Sub-Committee of Experts on the Transport of Dangerous Goods

Report of the Sub-Committee of Experts on the Transport of Dangerous Goods on its fifty-sixth session

Addendum

Draft amendments to the seventh revised edition of the Manual of Tests and Criteria (ST/SG/AC.10/11/Rev.7)

Figure 20.2: Examples of samples passing the thermal stress test

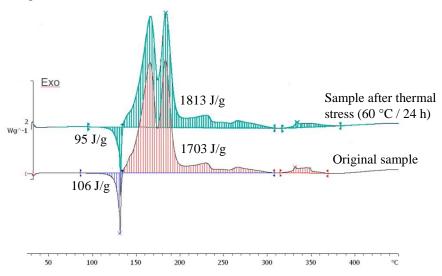
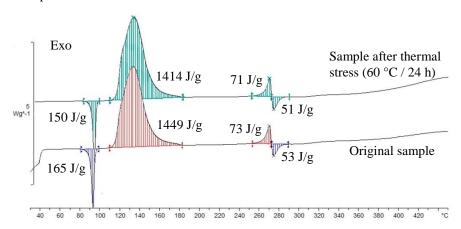
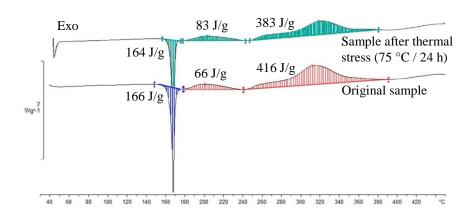
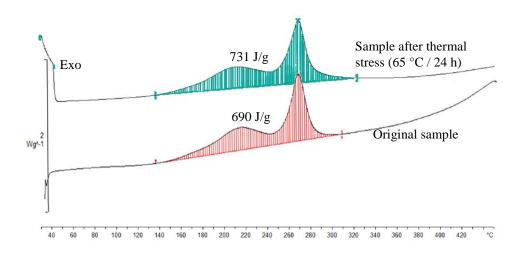
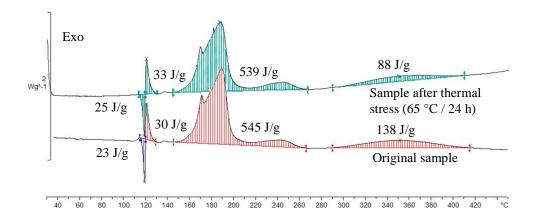
- 20.3.4.3 For purposes of determining the need for temperature control, a thermal stress test based on DSC measurements may be applied as follows: A DSC is measured as outlined in 20.3.3.3 for the sample as offered for transport. A second sample is taken, and thermal stress is applied by tempering the sample in the closed DSC crucible at a defined constant temperature over a certain period of time. In standard cases, a 24-hour stress time is deemed sufficient. The stressed sample is then cooled to room temperature before being subjected to a DSC measurement at the same heating rate as before. If the decomposition behavior remains unchanged by comparison of the two DSCs in terms of decomposition onset, shape of curve, and energy within a measurement uncertainty of 10 %, the sample is considered stable at the applied stress temperature. For flat peaks with a maximum heat production of 0.2 W/g a deviation of 25 % is tolerable in temperature ranges below 250 °C and 40 % above this limit. If the stress test is passed according to these criteria at 60 °C, then no temperature control is required.

- 20.3.4.5 Examples for passing the thermal stress test are shown in figure 20.2. Figure 20.3 contains examples of samples failing the stress test. A flow chart for the procedure is given in figure 20.4.

Figure 20.3: Examples of samples failing the thermal stress test

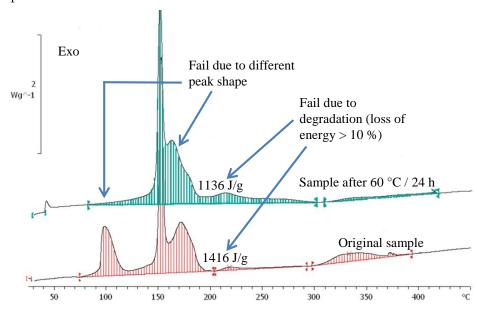
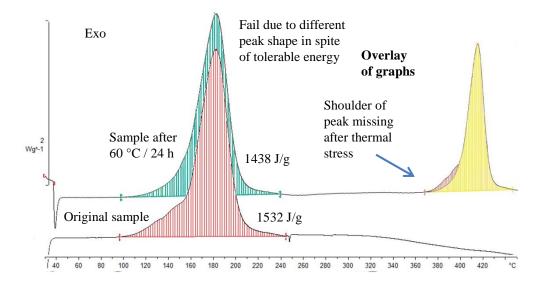
- 20.3.4.4 If the sample fails the stress test at 60 °C, then the same procedure should be applied at decreasing temperatures in steps of 10 K until the decomposition behavior remains unchanged. That temperature should be deemed the estimated SADT of the sample, and the control and emergency temperatures may then be derived in accordance with section 28.2.3 and table 28.2.

Figure 20.4: Flow chart scheme for the assessment of thermal stability of samples according to 20.3.4

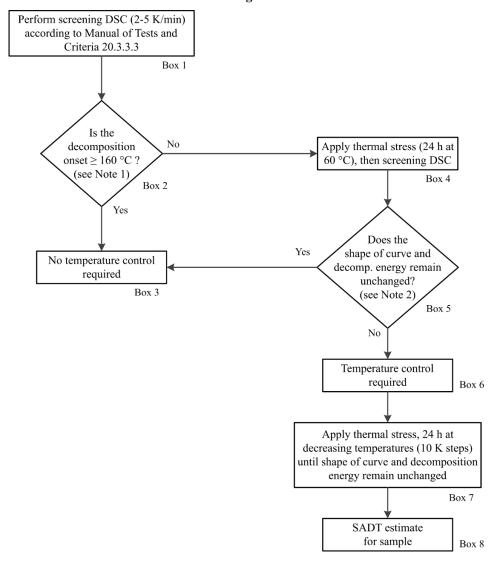
NOTE 1: Isolated small exotherm (< 20 J/g) preceding the main decomposition may be neglected;

NOTE 2: General tolerance for energy comparison due to measurement uncertainty: 10%. For flat peaks with a maximum heat production of 0.2 W/g a deviation of 25 % is tolerable in temperature ranges below 250 °C and 40 % above this limit."]
